Subject: Submittal of Chapter 7 Documents

Westinghouse is submitting responses to the NRC request for additional information (RAI) on SRP Section 7 and two additional reports. These RAI responses are submitted in support of the AP1000 Design Certification Amendment Application (Docket No. 52-006). The information included in the response is generic and is expected to apply to all COL applications referencing the AP1000 Design Certification and the AP1000 Design Certification Amendment Application.

Response to Request for Additional Information on SRP Section 7

Figure 7.1-2 Common Q Standard Process and AP1000 Project Specific Documents

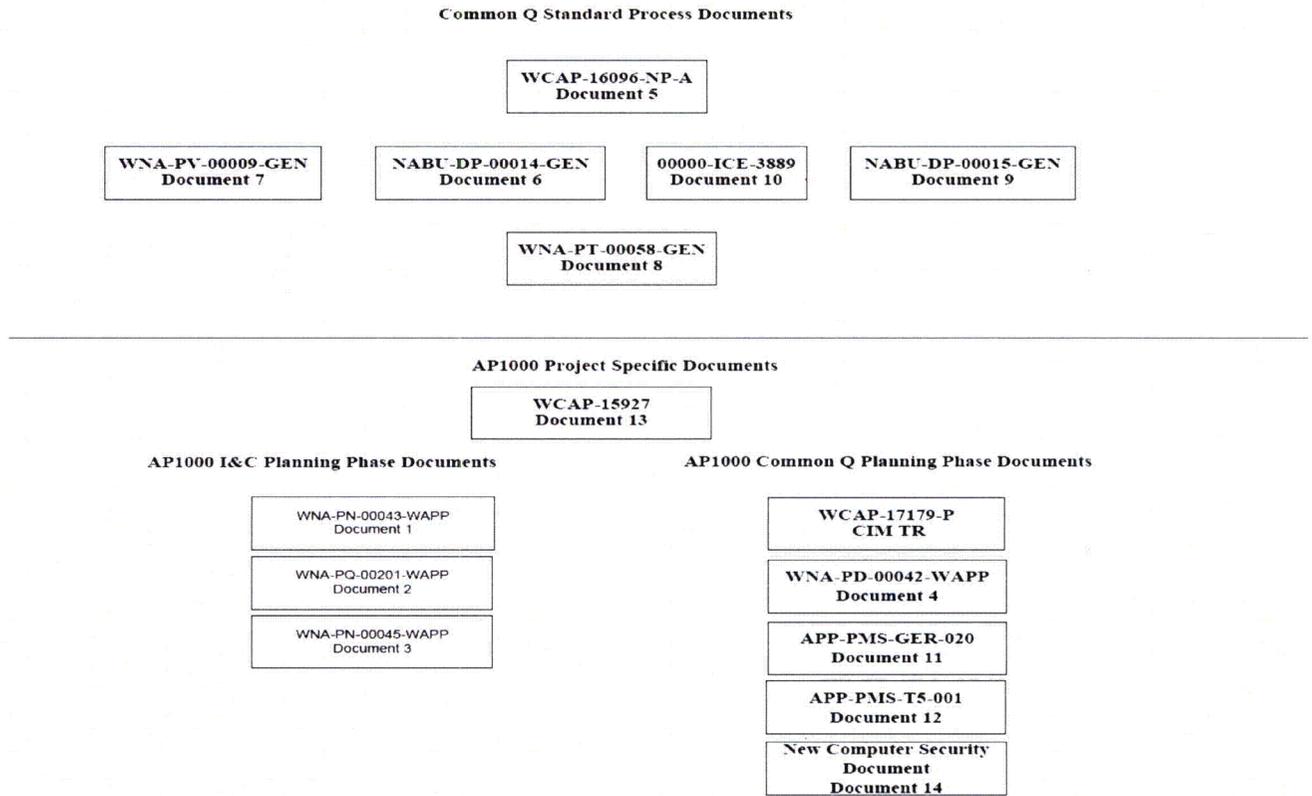
NRC Comment from 6/15/10 Meeting:

WEC is to provide a figure (document tree) and swap out the cyber/computer security reference.

The planning (or design requirements) phase documents are listed below. Figure 7.1-2 shows the relationship of the same documents.

The planning (or design requirements) phase documents are listed below. Figure 7.1-2~~xxxxx~~ shows the relationship of the same documents.
